# MY03 MONITORING REPORT

Hip Bone Creek Restoration Site  
Chatham County  
Cape Fear River Basin - 3030003

DMS Project #100059

Date: February 26, 2024  
To: Jeremiah Dow, DMS Project Manager  
From: Adam Spiller, Project Manager  
KCI Associates of North Carolina, PA  
Subject: MY-02 Monitoring Report Comments  
Hip Bone Creek DMS#100059, Contract 007528  
Cape Fear River Basin CU 03040101  
Chatham County, North Carolina

**CURRENT CONDITIONS PLANVIEW PAGE**  
**HIP BONE CREEK RESTORATION SITE**  
**CHATHAM COUNTY, NC**

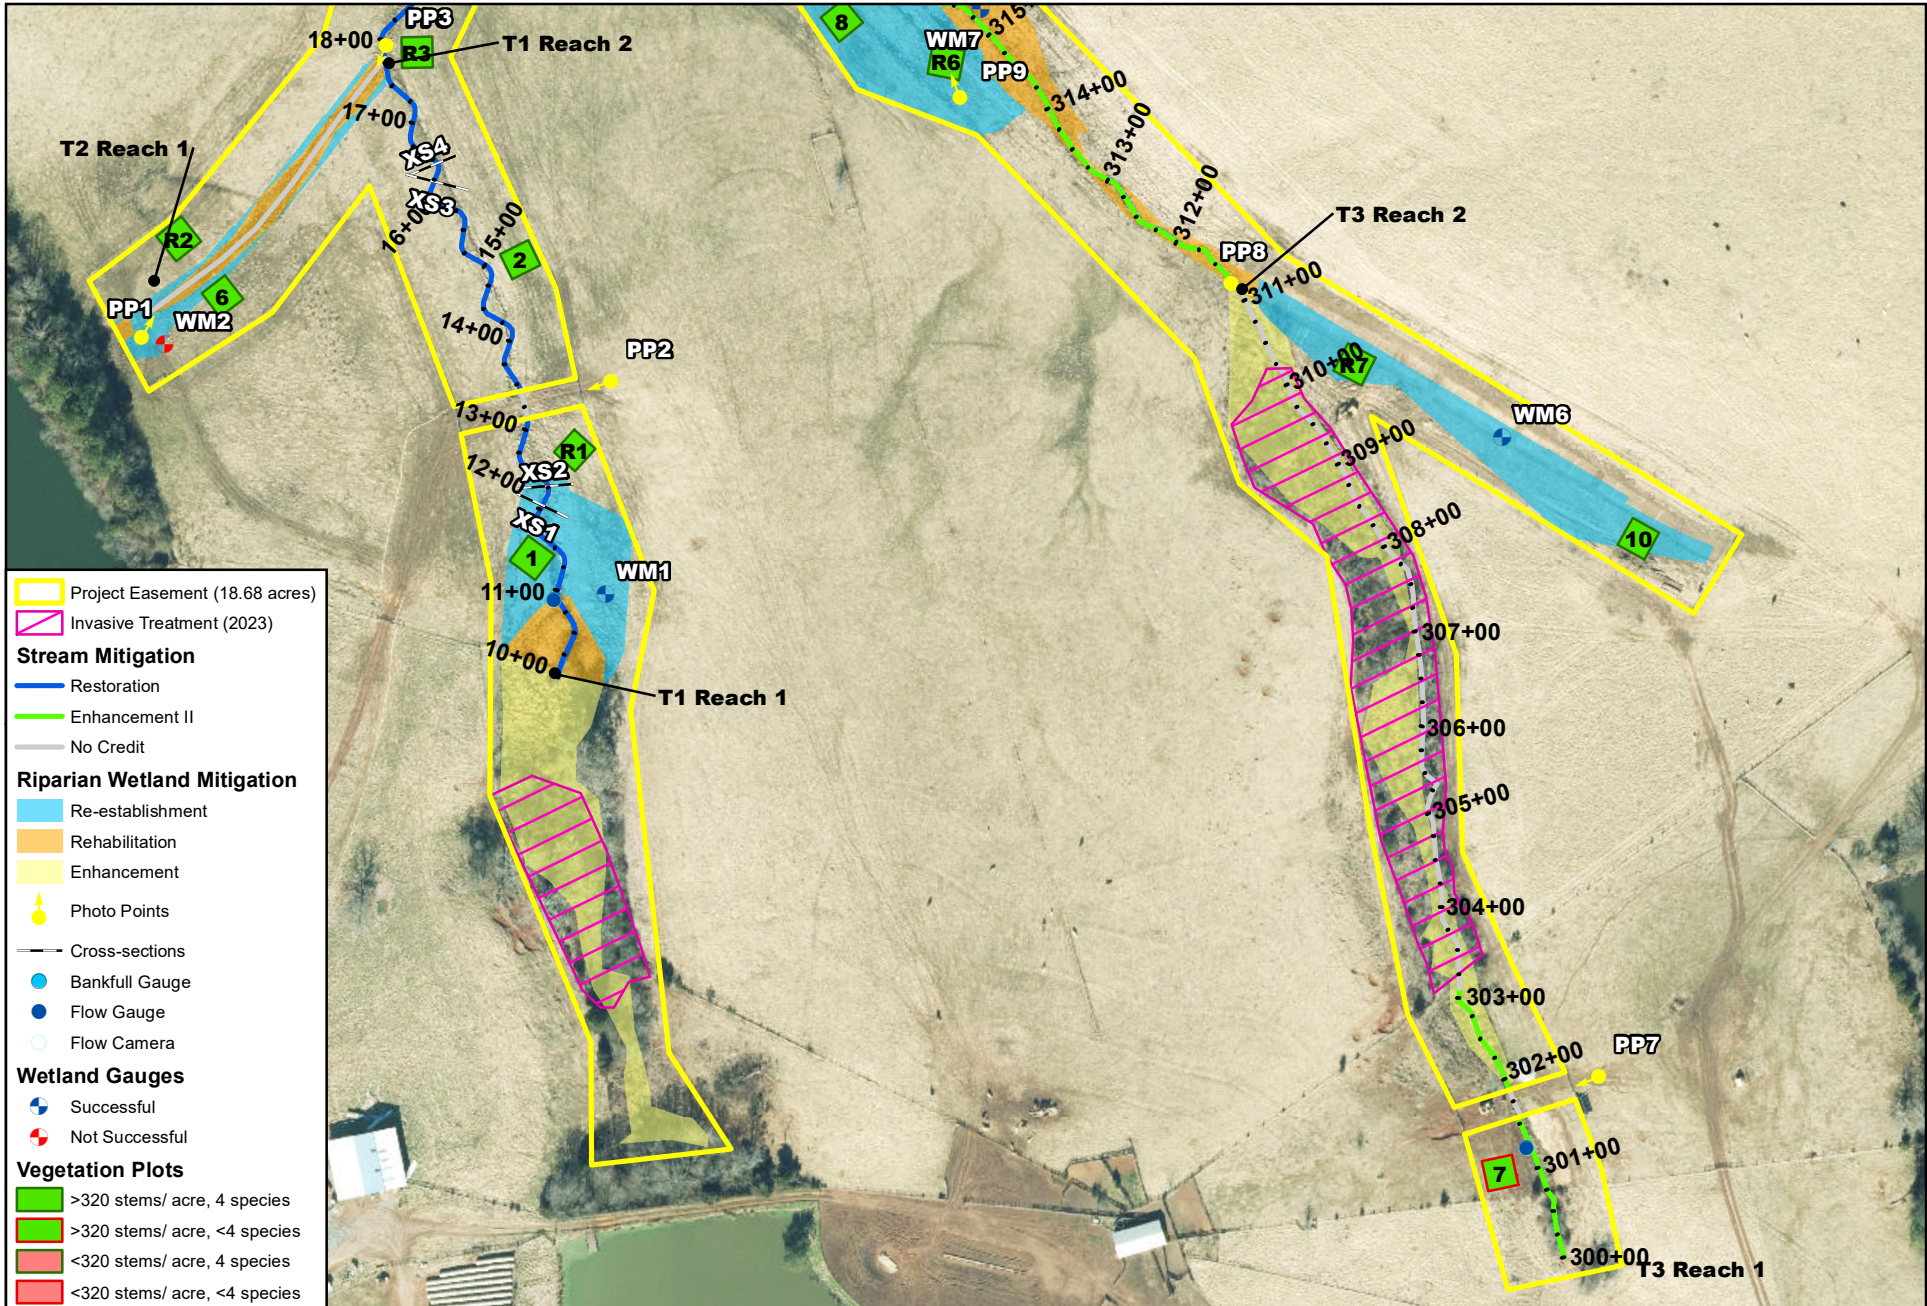
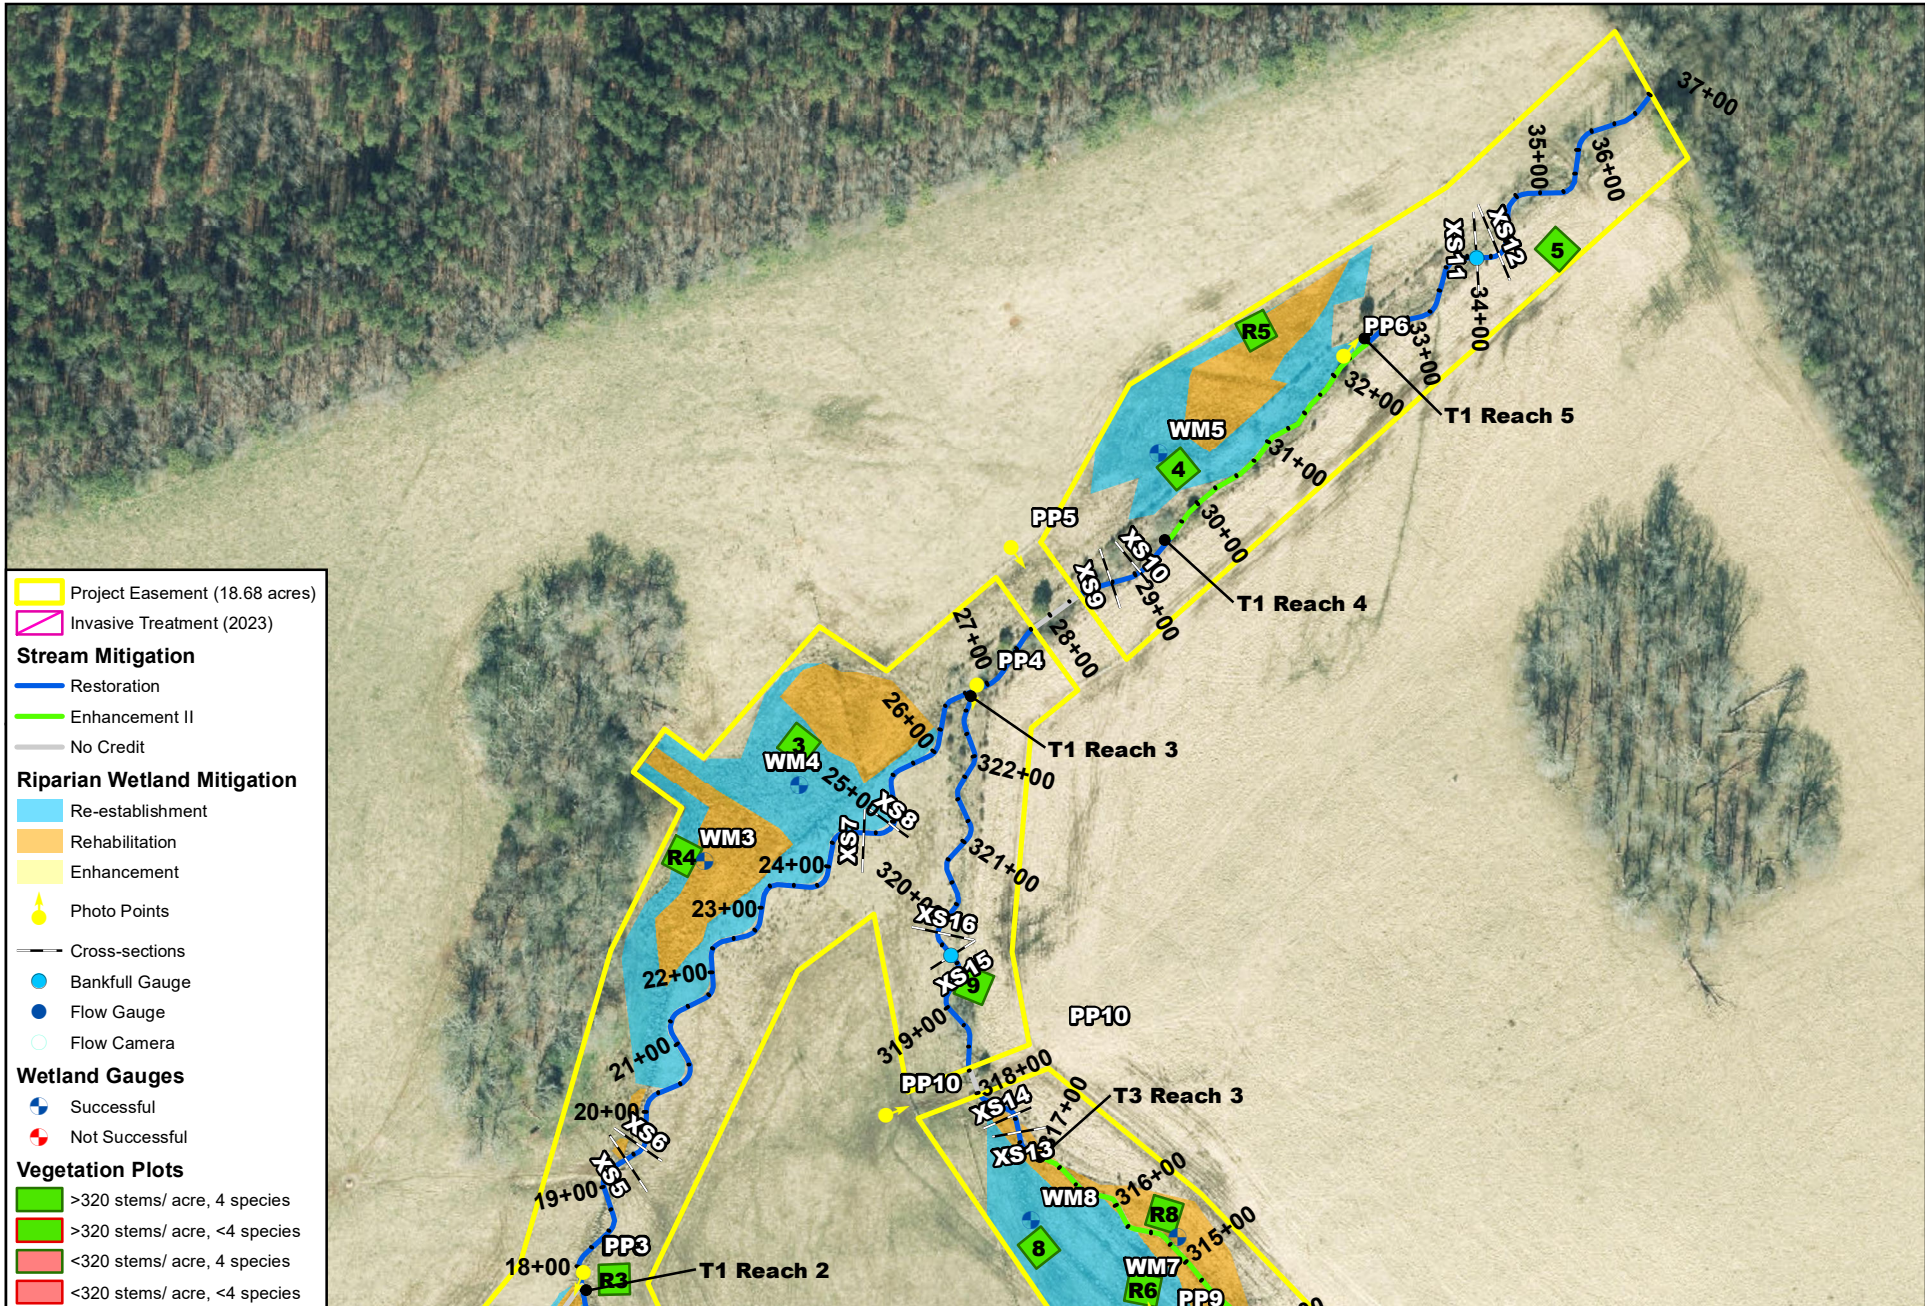
1. On the CCPV, recommend changing the wetland re-establishment color from red to a different, contrasting color. If a veg plot or GW gauge fail to meet success, it would be very difficult to see.  
*KCI Response: This change has been made.*

<b>River Basin:</b>	Cape Fear River
<b>Site:</b>	Hip Bone Creek Restoration Site
<b>XS ID</b>	XS13
<b>Drainage Area (sq mi):</b>	0.05
<b>Date:</b>	7/17/2023
<b>Field Crew:</b>	TS, CK, KB, ET

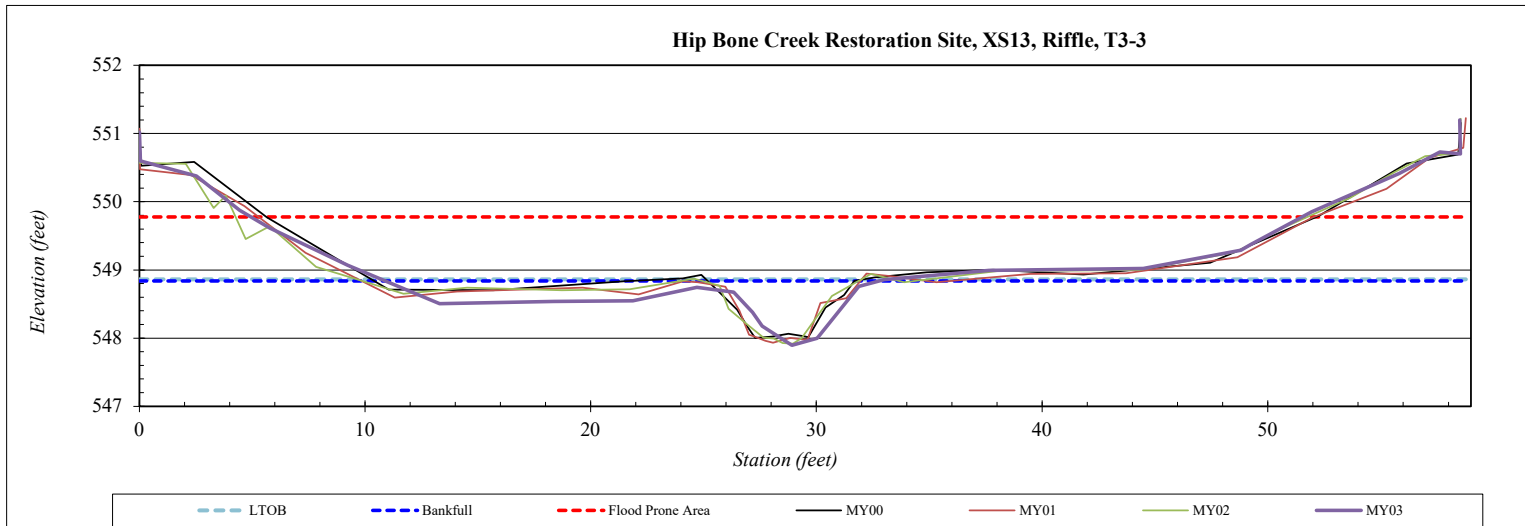
- c. Cross section 13 – please check the bankfull & LTOB lines on the graph. The location of the lines appears suspect and the reported change from a LTOB cross sectional area of 3 ft<sup>2</sup> to 1.1 ft<sup>2</sup> is questionable since the plot does not indicate aggradation to that degree.  
*KCI Response: The error with this cross section has been corrected and the morphology tables have been updated accordingly.*
